# Ransburg

## TRANSDUCER TUBING CONVERSION KIT

#### E-Z FLOW BASE SYSTEM (77357-0xxx & -2xxxx) (See Figure 1)

Figure 1: Base System Controller

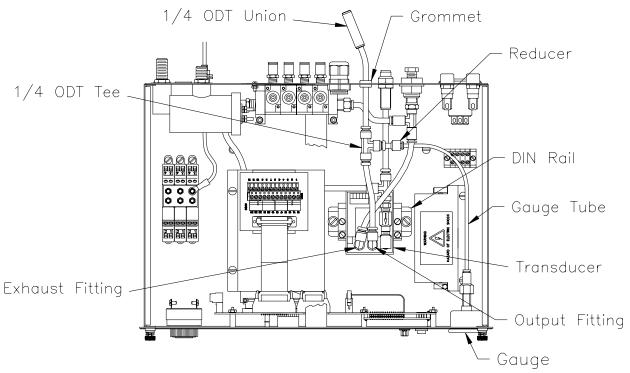
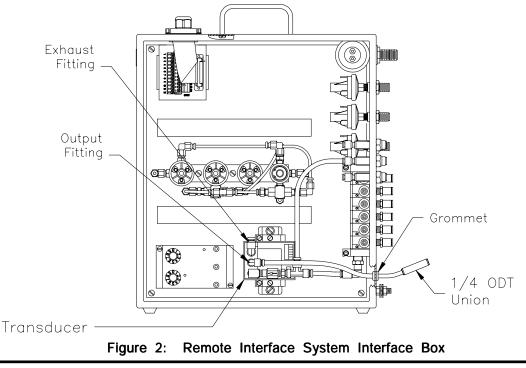
- 1. Disconnect existing tubing from transducer fittings. Using a screwdriver, remove the transducer from the DIN rail. Also remove 5/32 OD tubing from transducer output fitting (through the 5/32 ODT tee, if unit with gauge) to the 5/32 ODT bulkhead in the rear panel.

- 2. Replace the 5/32 ODT transducer output fitting with a 1/4 ODT SSP-6427 fitting from the kit. It will be necessary to remove and reinstall the transducer exhaust fitting to replace the transducer output fitting.

- 3. Remove the 5/32 ODT bulkhead fitting from the rear panel and replace with the grommet from the kit. Note: Earlier models used a bulkhead adapter instead of a 5/32 ODT bulkhead. For these models install the two SSP-6079 1/4 ODT x 1/4 NPTM fittings from the kit in both sides of the bulkhead adapter (remove existing fittings first).

- 4. If unit with gauge, replace the 5/32 ODT tee fitting with a 1/4 ODT tee fitting from the kit, using the 1/4 ODT to 5/32 ODT reducer in the leg of the 1/4 ODT tee (see Figure 1). Plug the gauge tube into the reducer.

- 5. Snap the transducer back onto the DIN rail and reconnect tubing as shown in Figure 1. Cut a piece of 1/4 OD tube from that supplied in the kit and plumb from the transducer output fitting to the 1/4 ODT tee or directly to the bulkhead adapter for units without gauge.

- 6. For units with gauge, cut another piece of 1/4 OD tube and plumb from the 1/4 ODT tee through the grommet on the rear panel as shown in Figure 1. On the outside of the rear panel, install the 1/4 ODT union on the tube passing through the grommet.

- 7. Replace the 5/32 ODT elbow on the top of the MVR at the fluid panel with the other 1/4 ODT elbow fitting supplied in the kit.
- 8. Using the 1/4 OD tubing from the kit, connect the output of the 1/4 ODT union (or bulkhead adapter) to the MVR. For proper operation this length must be at least 15 ft. (4.6 m). For optimum performance the tube should be as short as possible once the 15 ft. (4.6 m) minimum is obtained, preferably 25 ft. (7.6m) maximum. Never use more than 50 ft. (15.2 m).
